# Gene Snyder Freeway (I-265) Interchanges (US 60 and I-64)

**VALUE ENGINEERING STUDY**  
*for*  
Kentucky Transportation Cabinet

Study Date: June 10-14, 2002

**Final Report**

**I-265 / I-64 Interchange  
Alternate 2  
Item No. 5-021.0**

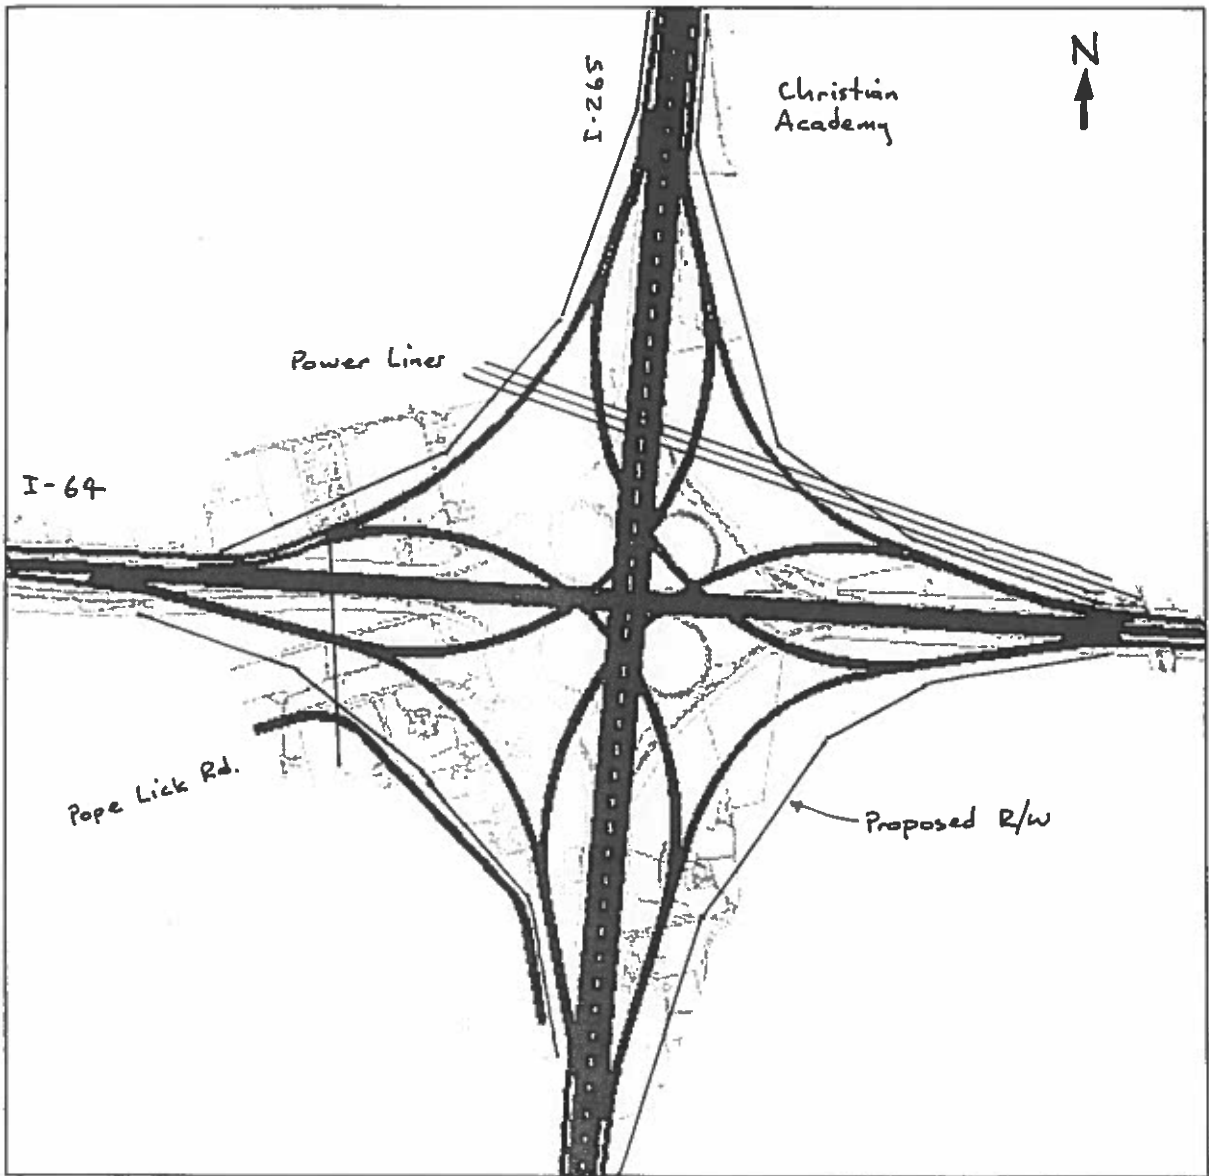
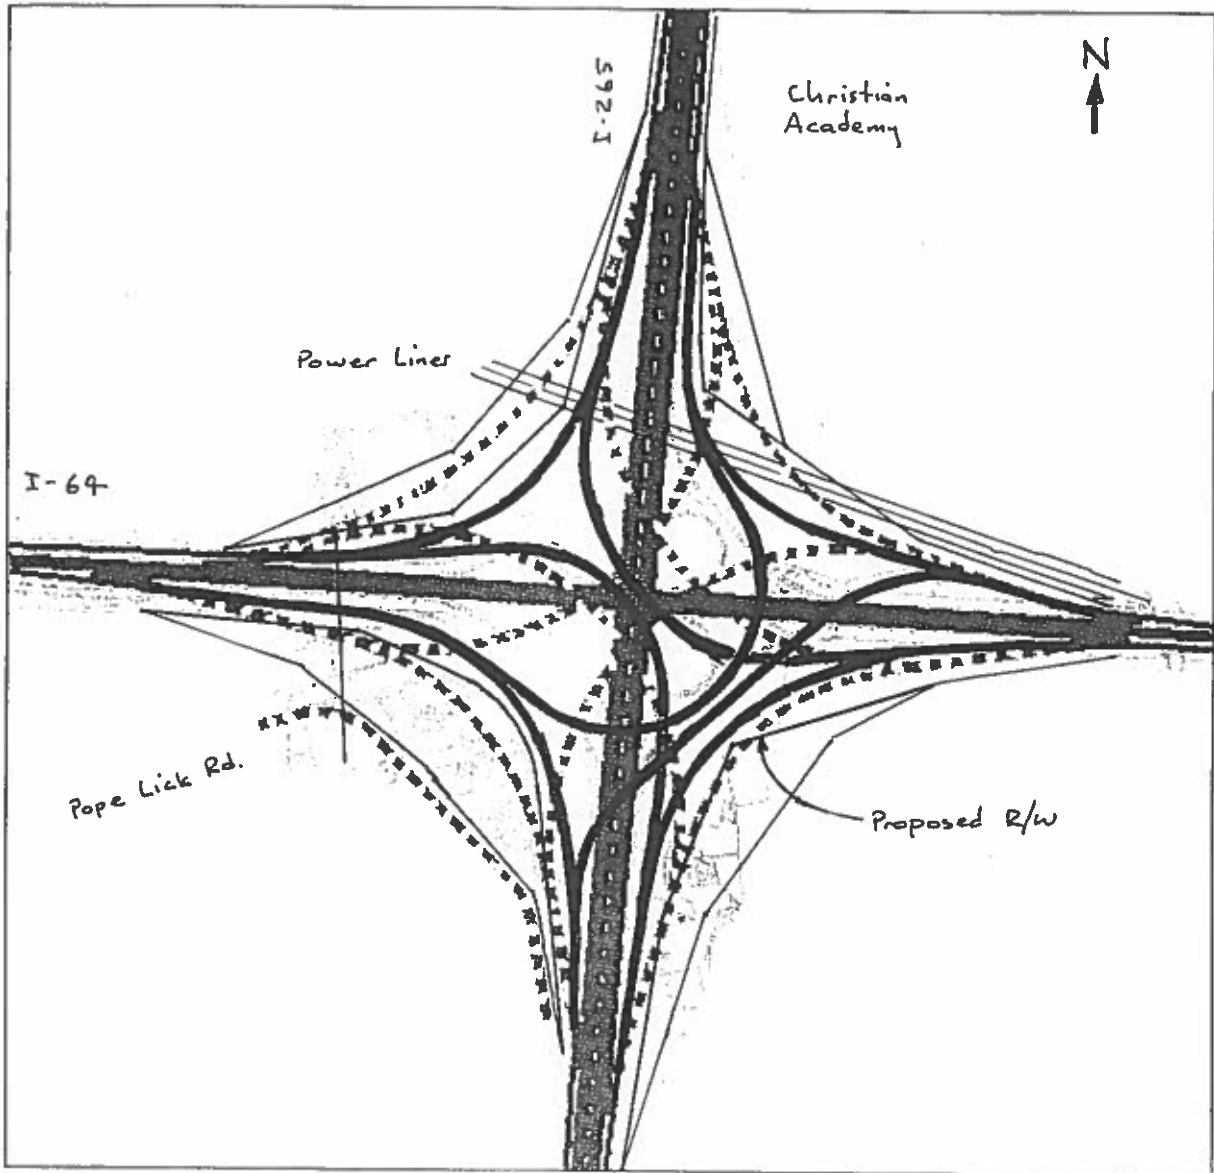
Reduce the radii of the ramps to more closely reflect the 50 mph design speed criteria. Relocate two of the interior ramps to outside of the current loop ramps.

The design speed of interstate flyovers on this project has been set by the FHWA to be 50 mph. This number was based upon the criteria for flyover ramp design speed to be 70% of the mainline design speed (i.e. 70% of 70 mph = 49 or 50 mph) . This proposal simply recommends that the project be designed to the criteria set for it and eliminate the excess design speed in the I-64/I-265 interchange ramps. The resulting design will functionally be equivalent to the original design (i.e. mitigation of congestion) while gaining the benefits of reduced right of way takes and cost savings.

Moving the interior ramps outside of the existing loop ramps would assist in maintenance of traffic by allowing the use of cloverleaf ramps during construction.

Only one tower of the power lines running north of the interchange will have to be relocated with the proposed alignment due to a reduction in total height of the interchange.

SKETCH OF ORIGINAL DESIGN

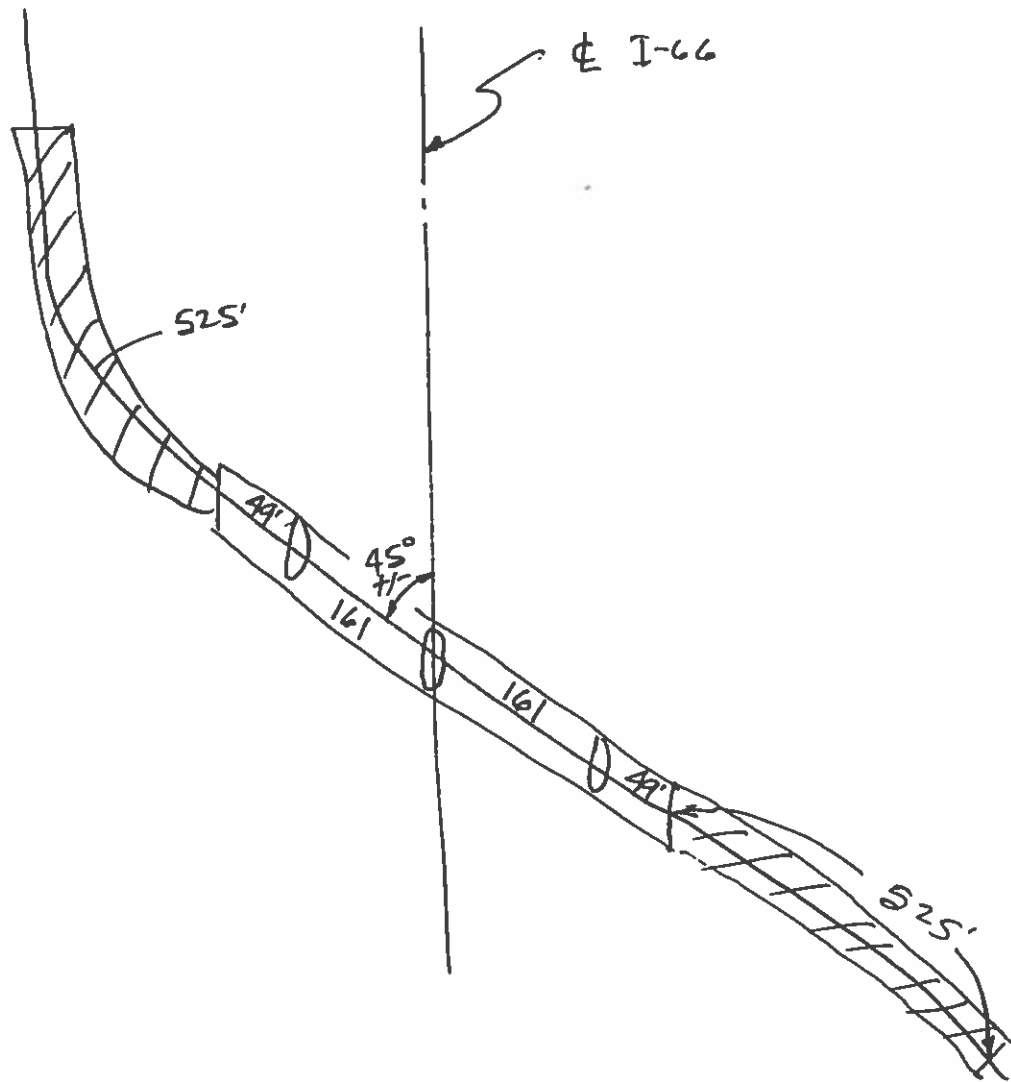
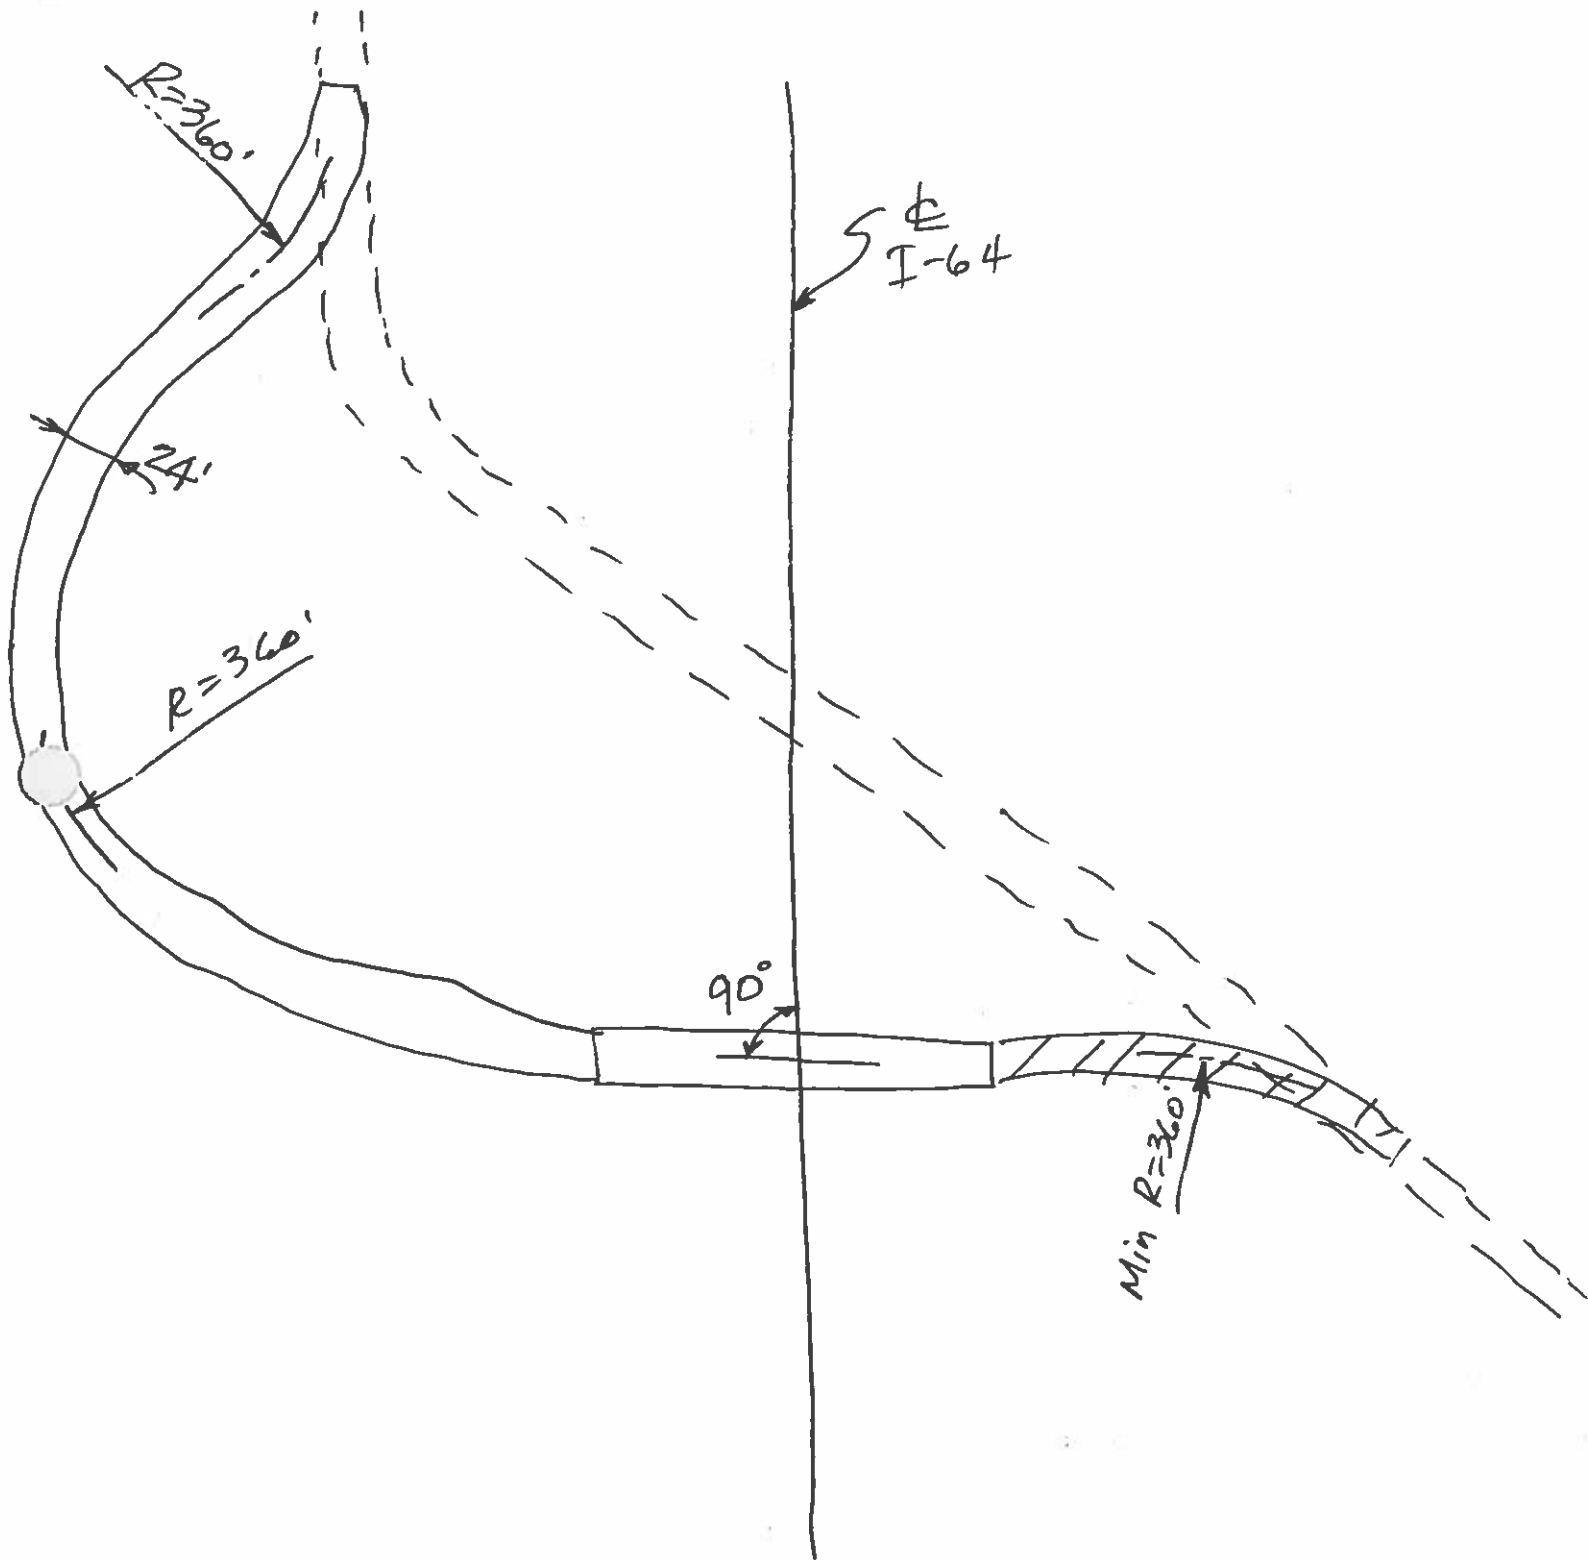
Realign Pope Lick Road with a crossing angle of 90 degrees to I-265.

This recommendation takes advantage of the fact that Pope Lick Bridge will be replaced as part of this project to realign the bridge consequently making it shorter.

The relocation of the bridge to the south will allow Pope Lick Road to remain open during construction until the traffic can be transferred to the new bridge.

SKETCH OF ORIGINAL DESIGN

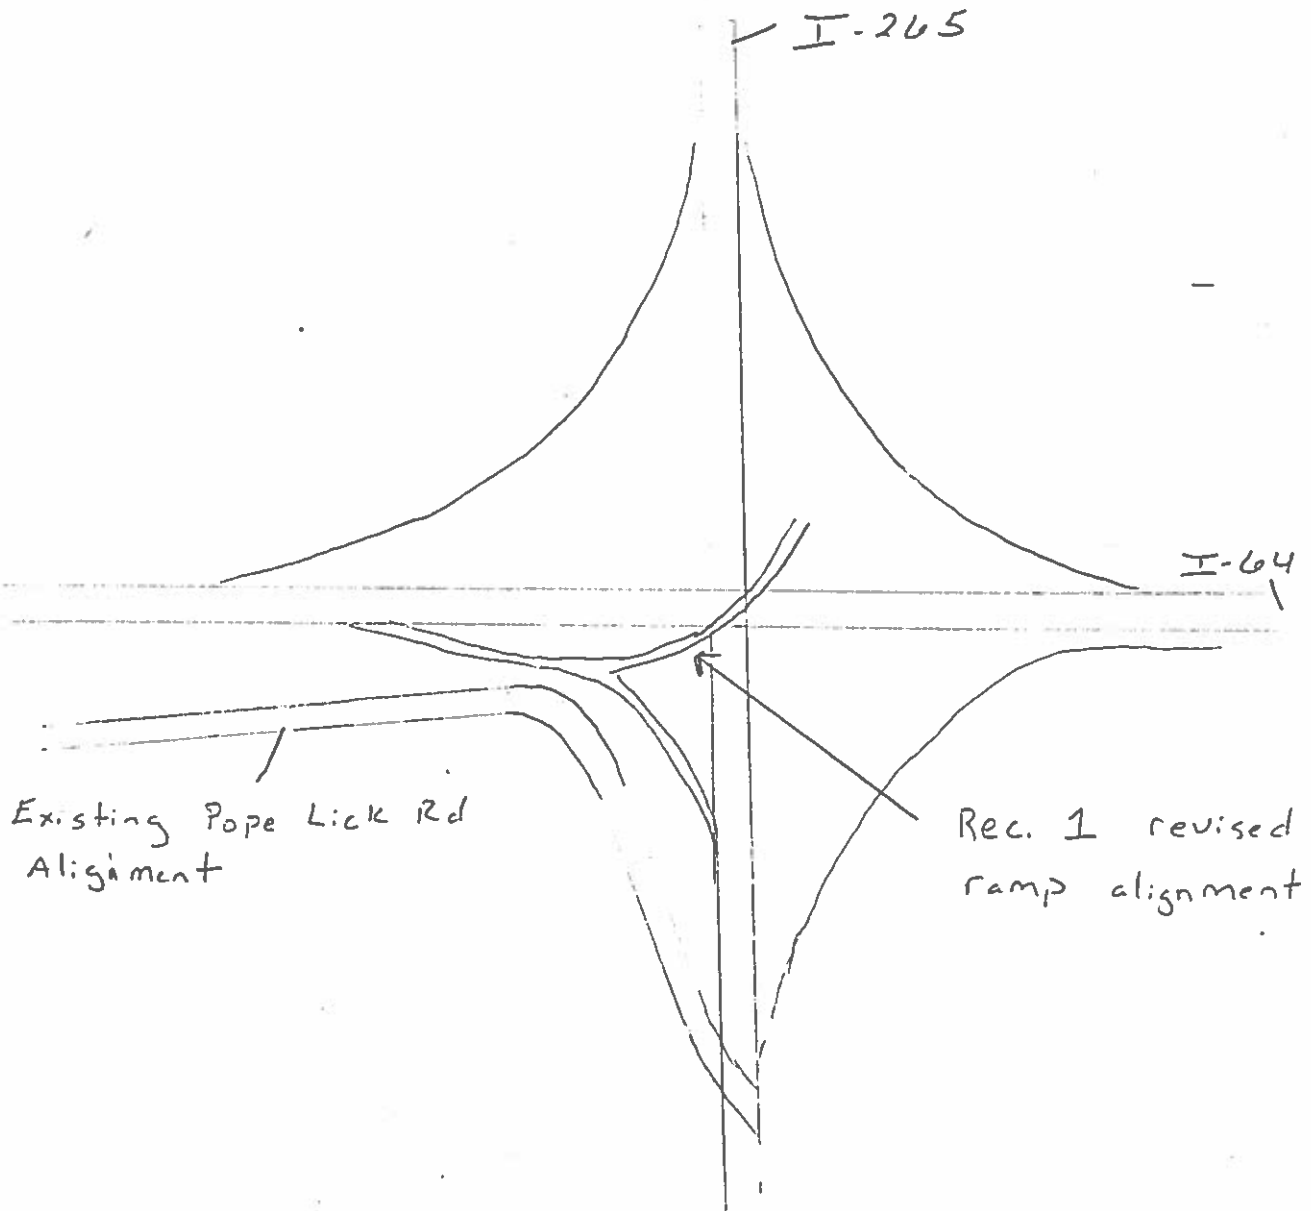
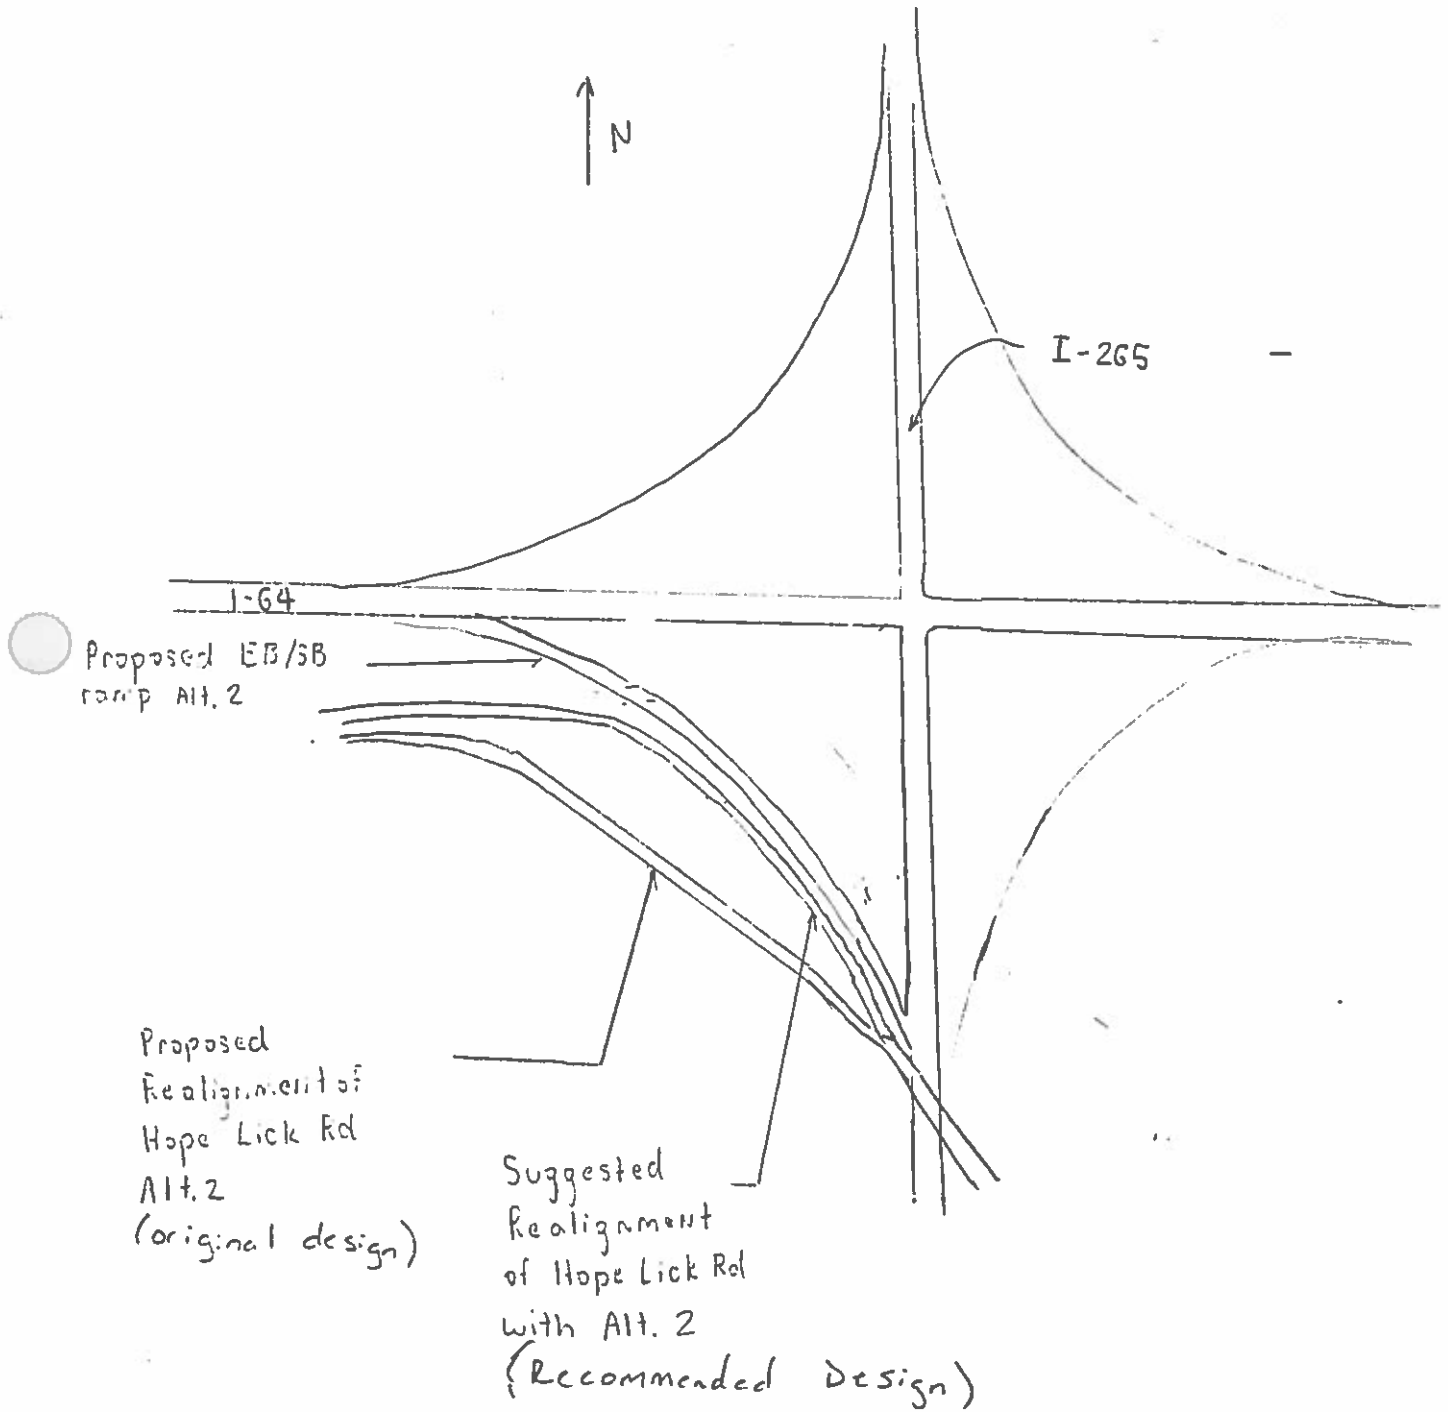
Realign Pope Lick Road to more closely parallel the EB to SB ramp.

Pope Lick Road is a relatively rural road with little traffic flow. The recommended change to the alignment would minimize the impact to the local community while relocating the road out of the interchange right of way.

There is a potential that if Recommendation 1 of the I-64 & I-265 Interchange is accepted, Pope Lick Road could remain on it's existing alignment and ROW (see Sketch # 2). This would maximize the benefit by eliminating the need to acquire any additional right of way for the Pope Lick Road relocation.
